TO: Board of Environmental Protection
 FROM: Staff, Bureau of Land Resources
 RE: Introduction to Bureau of Land Resources Memos
 Nordic Aquafarms, Inc. #L-28319-26-A-N/L-28319-TG-B-N/L-28319-4E-C-
 N/L-28319-L6-D-N/L-28319-TW-E-N
 DATE: May 13, 2020

TO: Board of Environmental Protection
FROM: Staff, Bureau of Land Resources
RE: Nordic Aquafarms, Inc. – Proposed Groundwater & Surface Water Usage
DATE: May 13, 2020

TO: Board of Environmental Protection
FROM: Staff, Bureau of Land Resources
RE: Nordic Aquafarms, Inc. – Proposed Impacts to Protected Natural Resources
DATE: May 13, 2020

“Soil Erosion & Sediment Control Phasing Plan-2 Phase 1A” and “Soil Erosion & Sediment Control Phasing Plan-2 Phase 2A” both dated October 25, 2019.

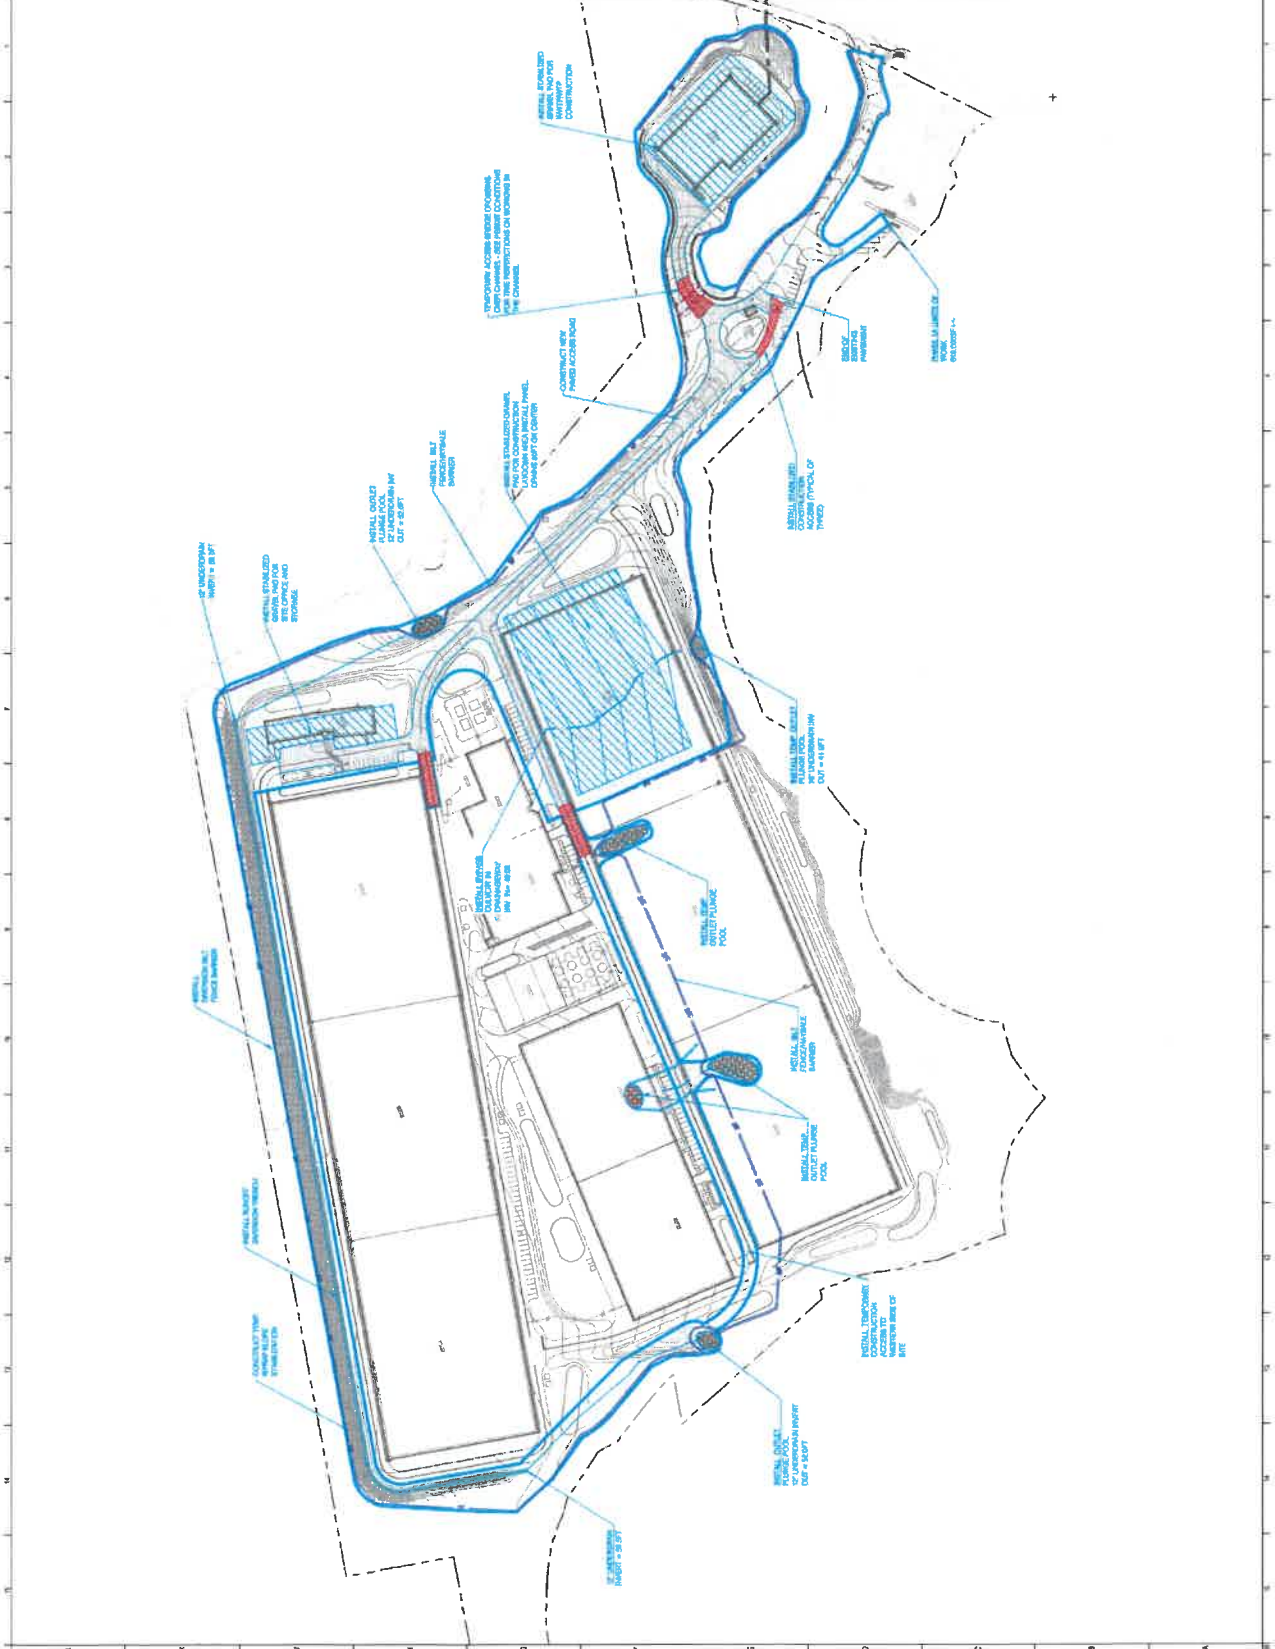
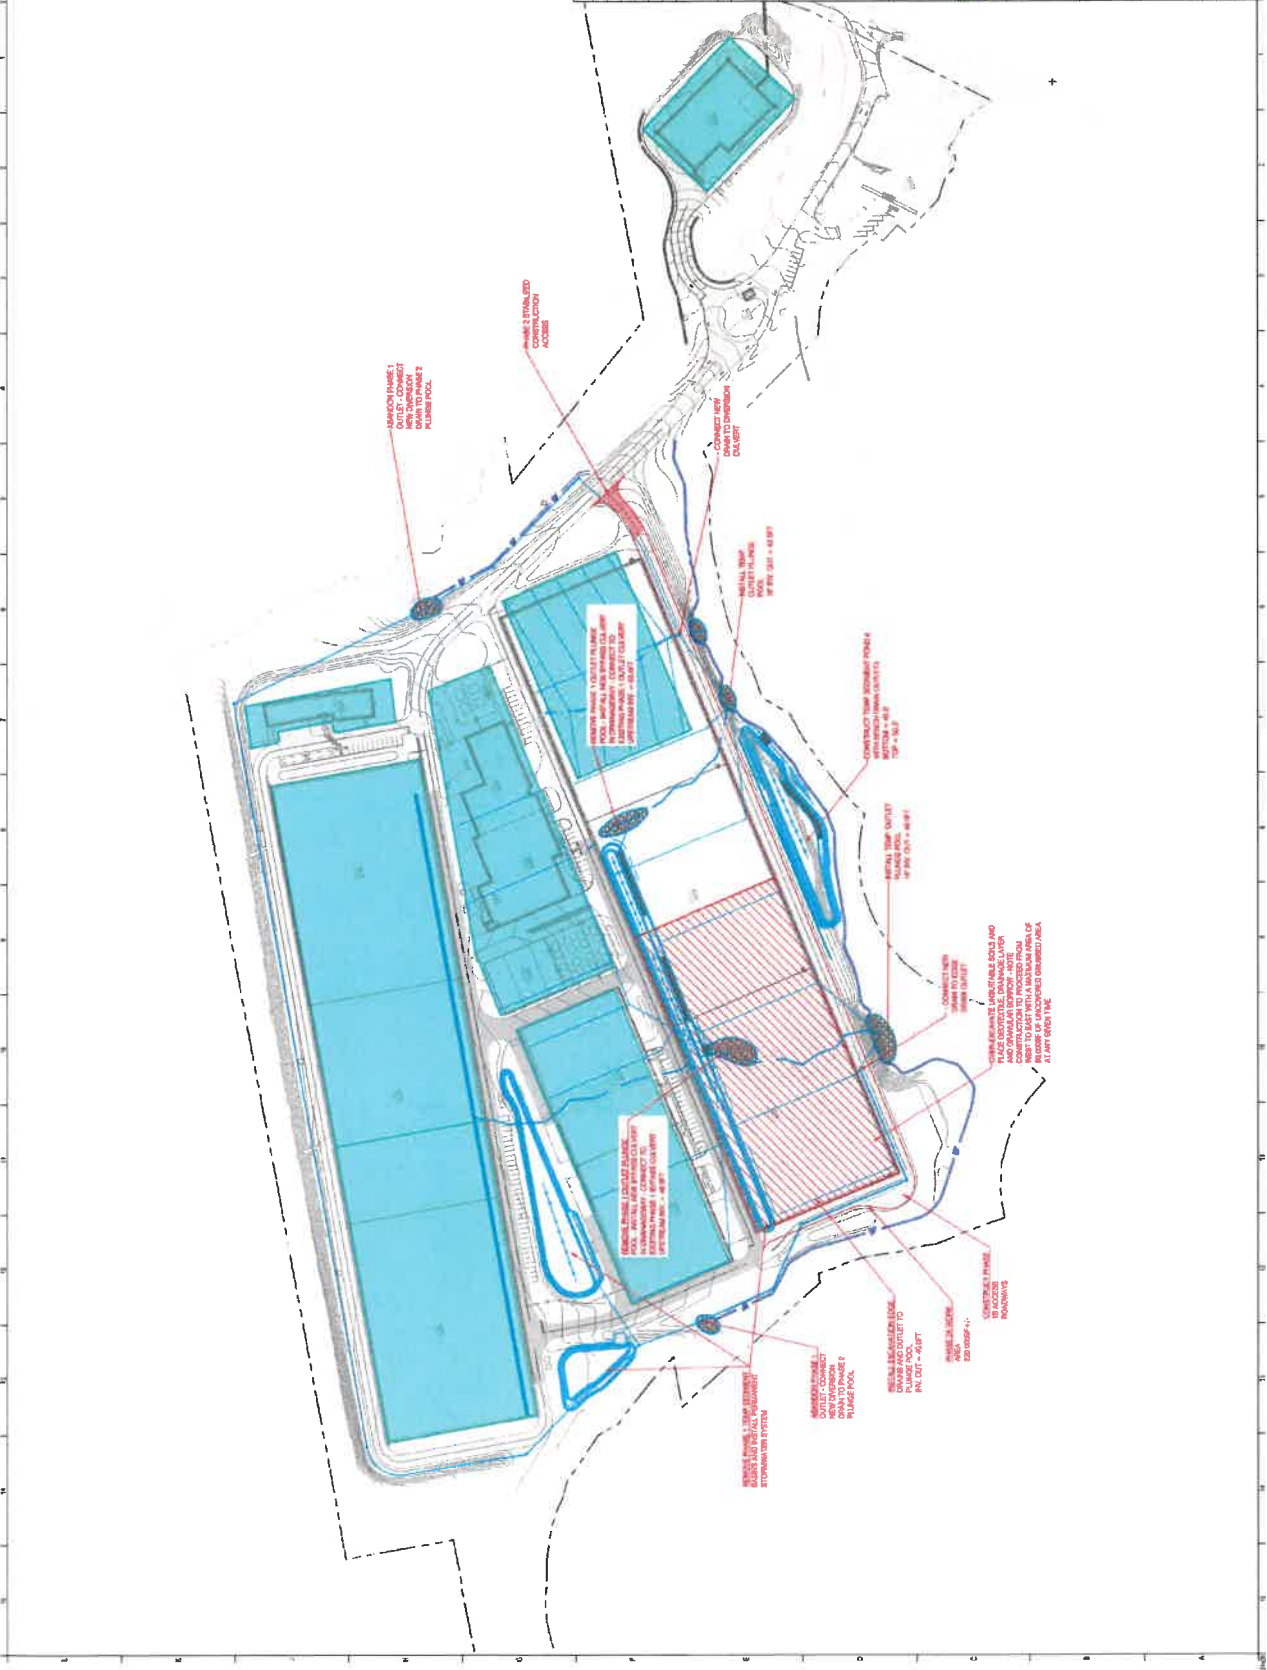
The project was reviewed by the Department's Bureau of Water Quality (BWQ). In its review, the BWQ raised concerns that, as the project was initially proposed, the filling of the upper reaches of Streams 3, 5 and 6 would reduce the amount of flow in the remaining downstream reaches of those streams. In response to these comments, the applicant designed a conveyance system, that would capture surface runoff and shallow groundwater from a diversion trench upgradient of the impacted stream reaches, and outlet the collected water into streams 3, 5 and 6 to maintain instream flow below the filled portions of those streams. As proposed, this under-drained conveyance system would maintain existing flow paths of the impacted streams and upgradient contributing areas. This conveyance system would be integral to maintaining existing natural water flow, water quality and aquatic habitat at the project site. Because of the importance of this system, staff have drafted possible conditions the Board may wish to consider as a safe guard to ensure compliance with relevant standards if the Board finds all the approval standards have been satisfied. The conveyance system is shown on the included attachments,
